Access Compliance Report

Public Rights-of-Way

(Curb Ramps)

Intersection ID: 30180	Main Street: ACORN_VALLEY_CT	Cross Street: HIDDEN_CREEK_DR	Location: NW
ADA ID: 1320B1DB20B9	Ramp Type: PerpDiag	Initial Pass/Fail: Fail	Overall Compliance: No
Codes/Mitigation Info/Possible Solution		Field Measurements/Component Compliance

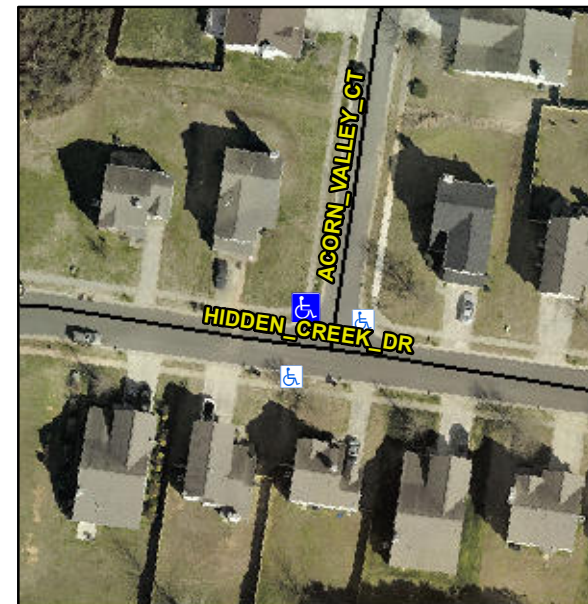
Not Found, R304.5.1, R304.2.2

Compliance	Description	Data	Compliance	Description	Data
N/A	Ramp Length (in)	48.0	No	Ramp Slope (%)	8.7
No	Ramp Width (in)	40.0	Yes	Ramp XSlope (%)	2.0
N/A	Flare Type LT	N/A	N/A	Flare Type RT	N/A
N/A	Flare Slope LT (%)	N/A	N/A	Flare Slope RT (%)	N/A
N/A	Flare Traversable LT?	N/A	N/A	Flare Traversable RT?	N/A
N/A	Landing Length (in)	N/A	N/A	DWS Provided?	N/A
N/A	Landing Width (in)	N/A	N/A	DWS Contrast?	N/A
N/A	Landing Slope (%)	N/A	N/A	DWS Length (in)	N/A
N/A	Landing X Slope (%)	N/A	N/A	DWS Full Width?	N/A
N/A	Landing Curb? (Y/N)	N/A	N/A	DWS Offset (in)	N/A
N/A	Shared Landing?	N/A			
N/A	Gutter Ponding?	N/A	N/A	Gutter Slope (%)	N/A
N/A	Gutter Lip Ht (in)	N/A	N/A	Gutter X Slope (%)	N/A
N/A	Painted X Walk1?	No	N/A	Painted X Walk2?	No
	X Walk 1 Direction	To S		X Walk 2 Direction	To E
N/A	X Walk 1 Width (in)	N/A	N/A	X Walk 2 Width (in)	N/A
	X Walk 1 Slope (%)	4.1		X Walk 2 Slope (%)	3.0
	X Walk 1 X Slope (%)	2.0		X Walk 2 X Slope (%)	2.0

Remove & Replace Curb Ramp With Two New Directional Ramps or Equivalent.
